WENDELL AVENUE BRIDGE (Project 63291)

OPEN HOUSE MEETING

October 29, 2013

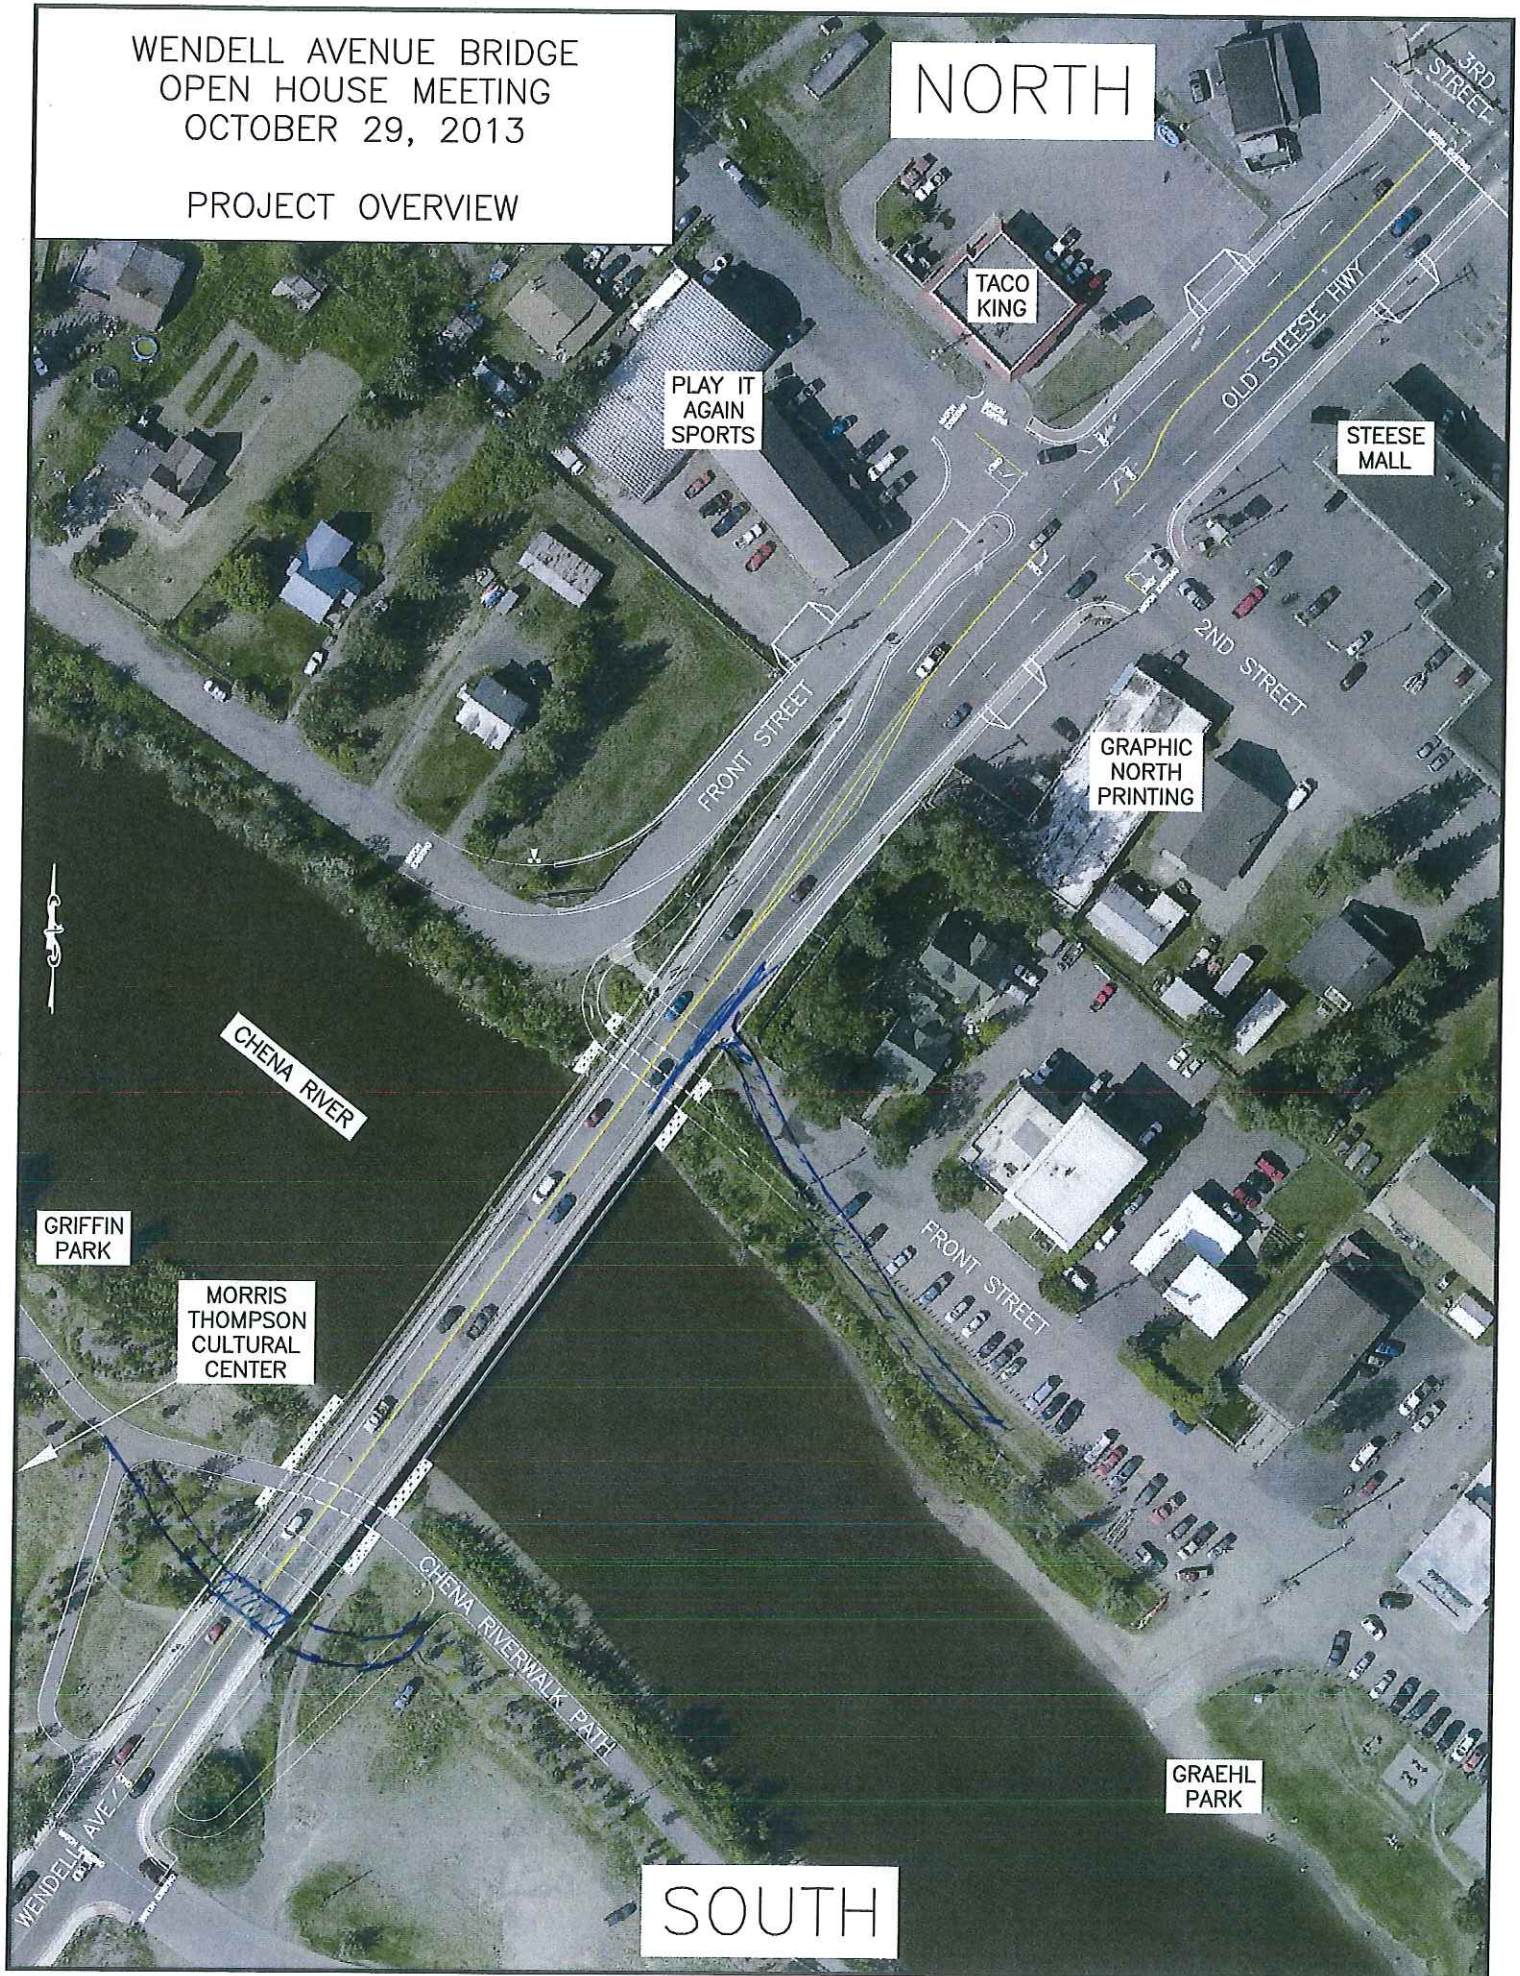
I really enjoyed the presentation and I enjoy aspects of the project. First, I really enjoy the addition of a ramp on the SE side of bridge. I would love to see both sides of path be brought further up the bridge (closer to water) to facilitate quick on and off for peds. It is an inconvenience for peds to walk so far from the river path to cross the bridge.

On the other side (N side) there should be a ramp on both sides. It is incredibly inconvenient for people to walk under, around, and on top of the bridge to travel from east to south.

Where the proposed path meets the old steese on the north side of the river is incredibly narrow. Turning on a bicycle to go south would be tough/dangerous for children/elderly.

Could natural materials like plants, trees, reeds, etc. be used in addition/in place of rip rap? Natural materials will hold the embankment better and reduce sediment loss.
